8. Address/Description: 3502 BROADWAY
HDRC Case No.: 2024-073
Historic District Name: Tobin Hill
RIO District: RIO-1
Applicant: Louis Talamantez/LT Electric, LLC
Request: Signage, lighting
City Council Dist.: 2

HISTORIC AND DESIGN REVIEW COMPLIANCE AND TECHNICAL ADVISORY BOARD

HDRC CASE NO: 2024-073
ADDRESS: 3502 BROADWAY
LEGAL DESCRIPTION: NCB 6138 BLK LOT 45- 46
ZONING: C-2, RIO-1
CITY COUNCIL DIST.: 2
DISTRICT: Tobin Hill Historic District
APPLICANT: Louis Talamantez/LT Electric, LLC
OWNER: Carim Khanmohamed/Smoke Shop
TYPE OF WORK: Signage and installation of window film
APPLICATION RECEIVED: January 19, 2024
60-DAY REVIEW: March 19, 2024
CASE MANAGER: Jessica Anderson
REQUEST:

FIVE 5 STAR SMOKE SHOP

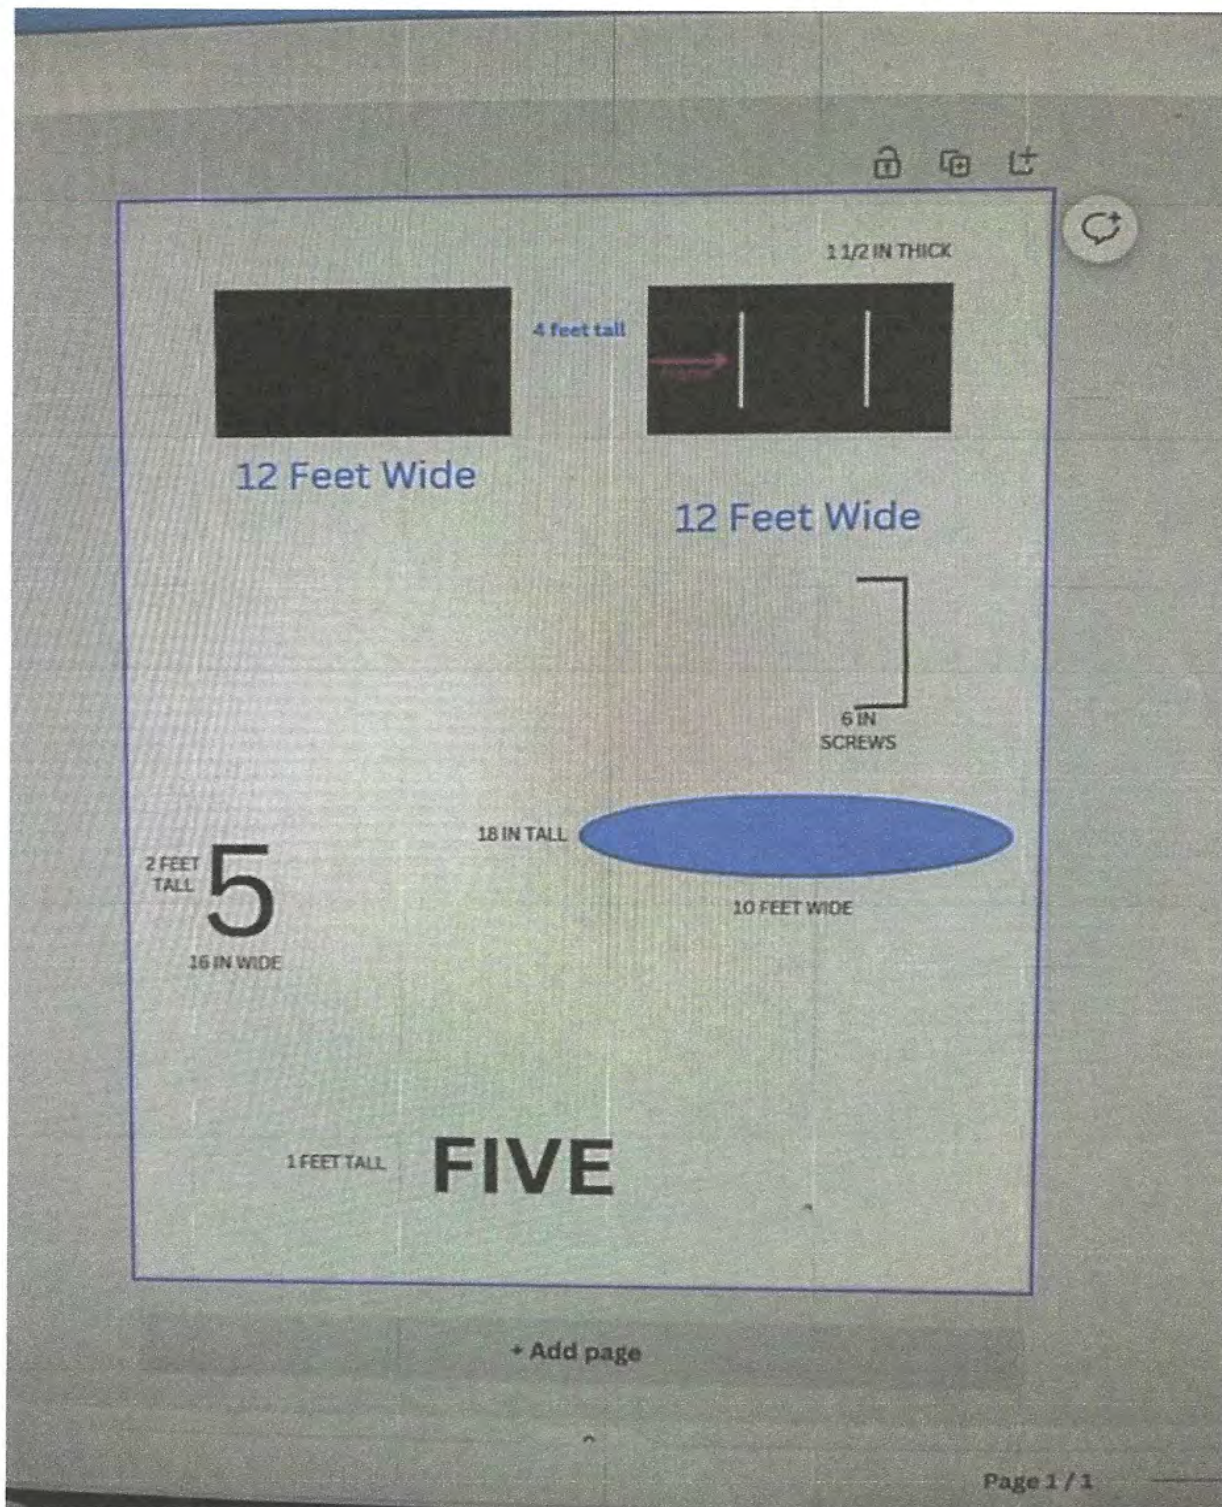
- b. **SIGNAGE:** The applicant requests approval to install signage, including an internally illuminated sign mounted on a 12'x4' backing and window vinyl featuring the business logo in four locations. UDC 35.678 says applicants may apply for up to three (3) signs total. Total signage for all applicants shall not exceed fifty (50) square feet unless additional signs and/or additional total footage is approved. Additional square footage may be approved provided that the additional signage is in conformity with, and does not interfere with, the

pedestrian experience on the Riverwalk. The additional square footage shall be based upon the size and scope of the site. The parapet sign is 48 square feet including the backing. Staff was unable to determine the dimensions for window signage found on site, but the total square footage of the logos on the window vinyl exceeds 2 square feet. Staff finds the signage does not conform to UDC and should be reduced to three signs that do not exceed 50 square feet in total.

- i. That the applicant reduces signage to no more than three signs that are equal to or less than 50 square feet in total, as noted in finding b. This includes reduction of window clings to conform with signage standards, as noted in finding c.
- ii. That the applicant proposes under-eave lighting that conforms to UDC 35.673, namely lighting that is shielded to reduce glare and with a lighting temperature that meets RIO standards, as noted in finding d.

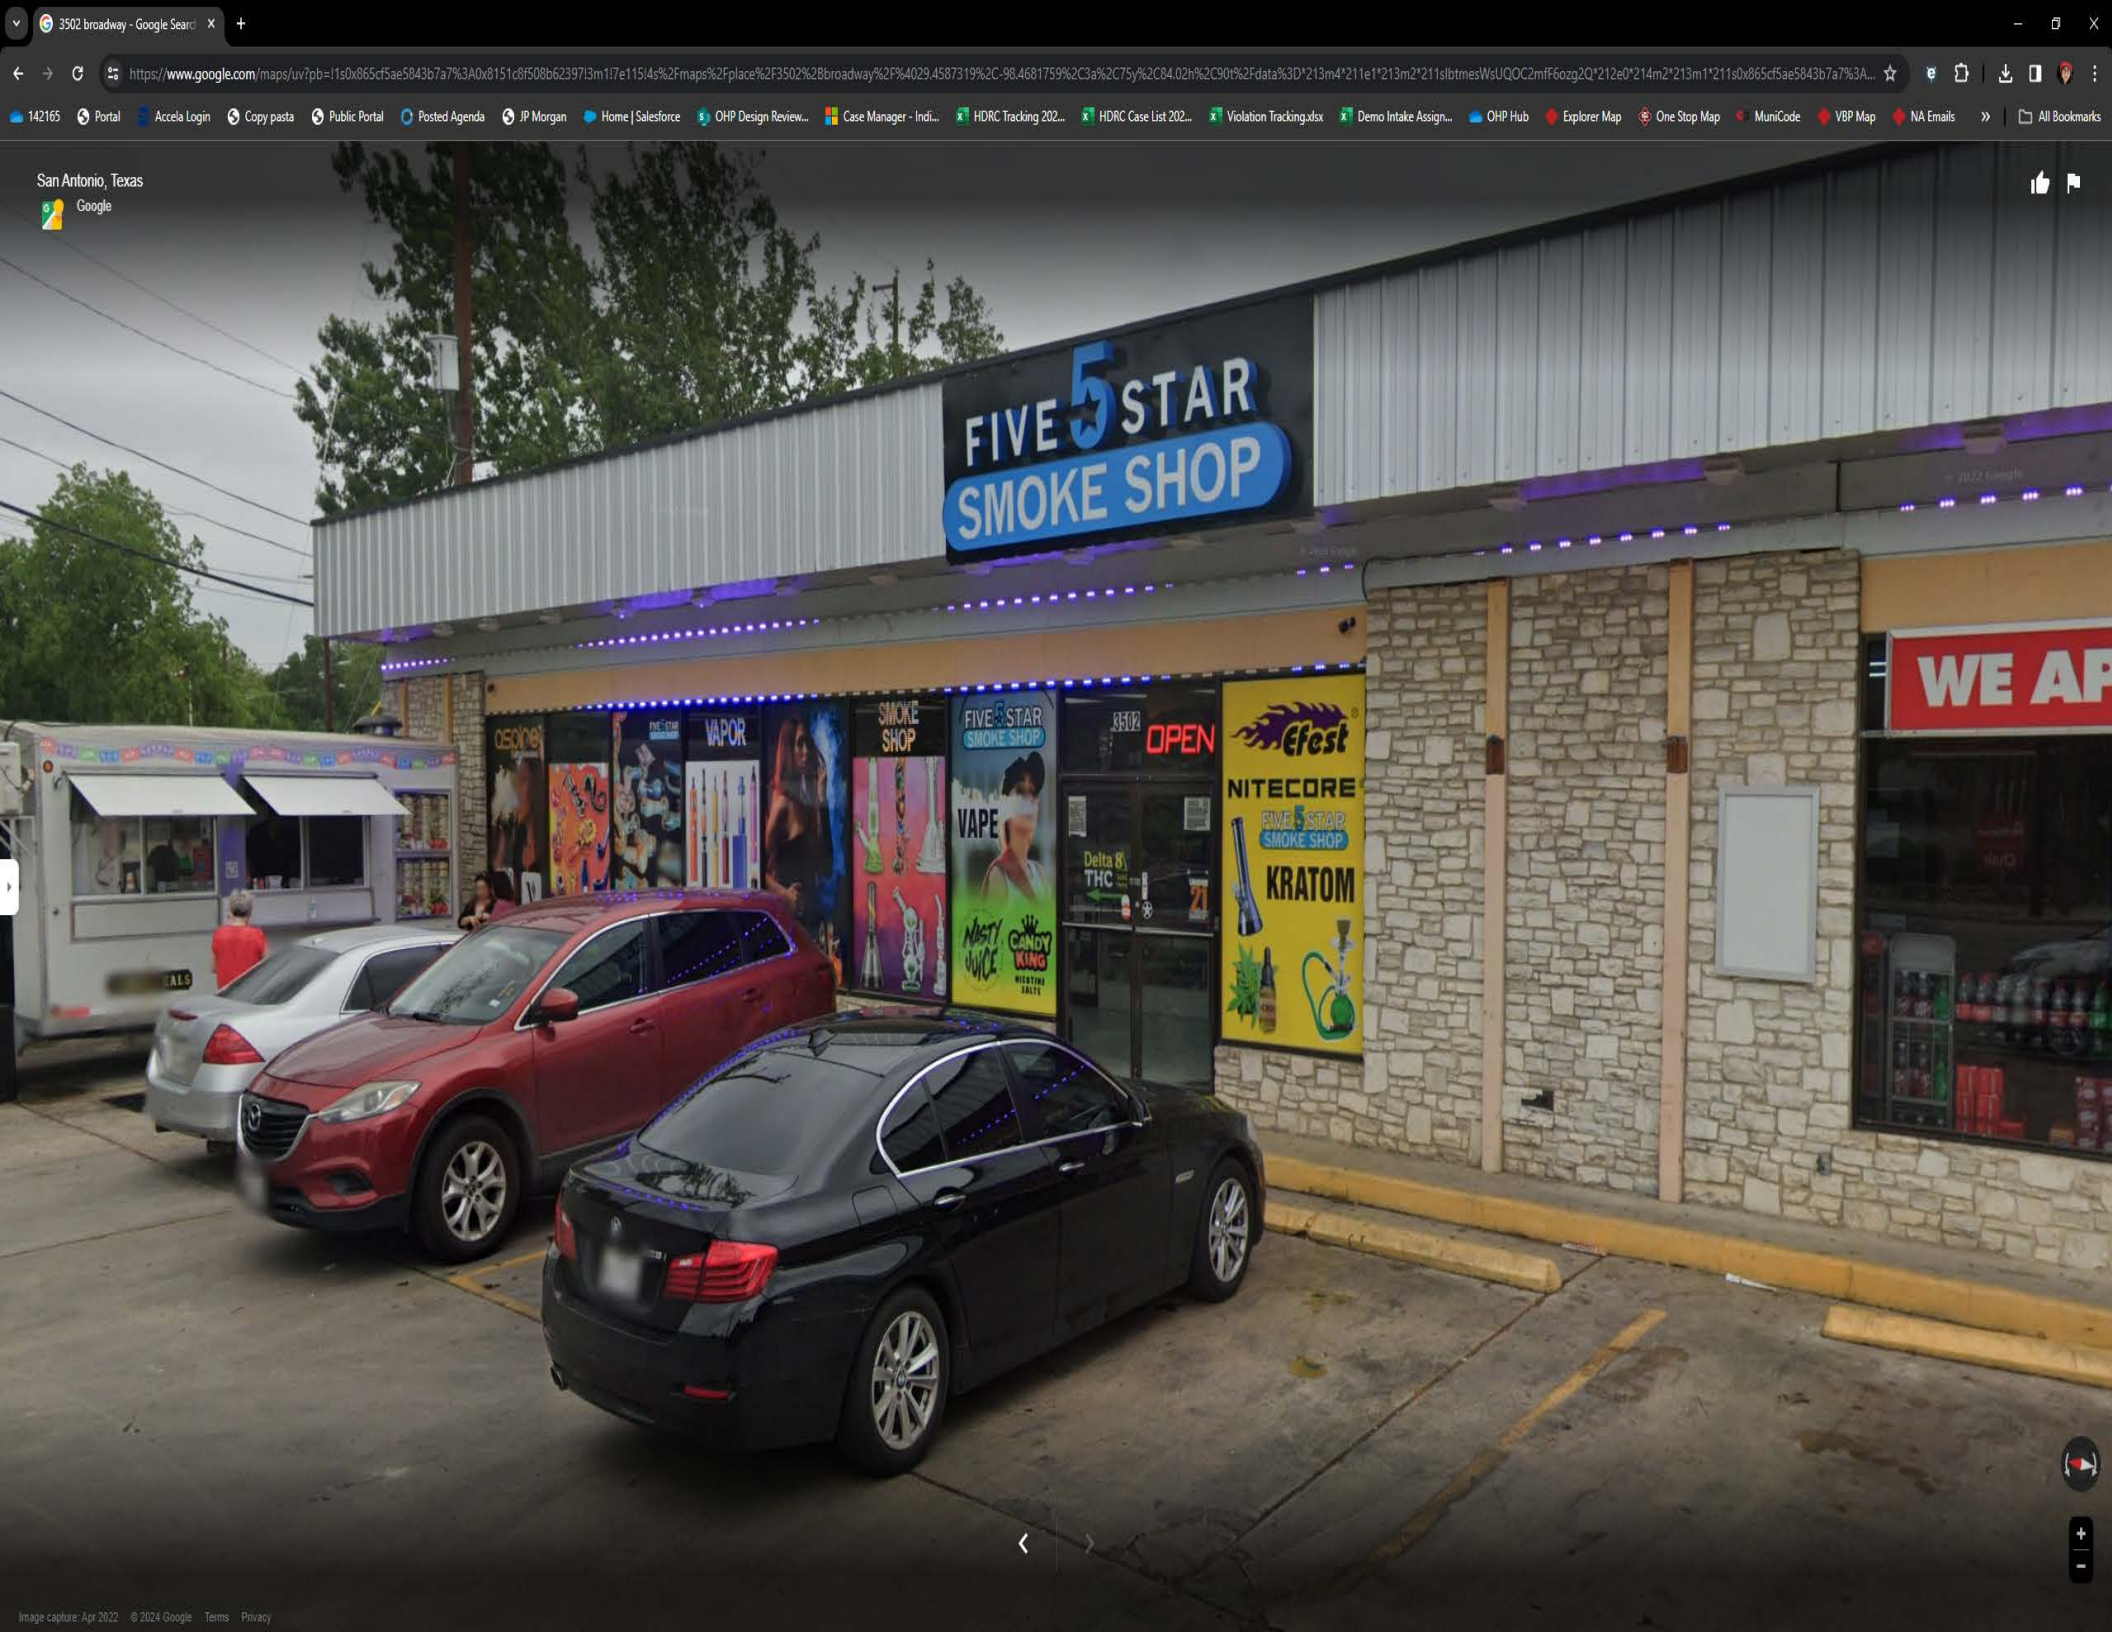
- c. **WINDOW VINYL:** The applicant requests approval to install full window vinyls across the elevation. All graphic elements shall reinforce the architectural integrity of any building. Signs shall not disfigure, damage, mar, alter, or conceal architectural features or details and shall be limited to sizes that are in scale with the architecture and the streetscape. Emblems and symbols of identification used as principal structural or architectural design elements on a facade shall not be included in the total allowable signage per facade per structure when approved. Review shall be guided by the building's proportion and scale when such elements are incorporated. Staff finds the window vinyl inappropriate and that overall window coverage should be reduced.

- d. **LIGHTING:** The applicant requests installation of under-eave lighting along the primary elevation of the building. UDC 35-673 says all security lighting shall be shielded so that the light sources are not visible from a public way, and that light temperature and color shall be between 2500°K and 3500°K with a color rendition index (CRI) of eighty (80) or higher, respectively. Levels shall be determined by product specifications. Staff finds the under-eave lighting does not conform to UDC.
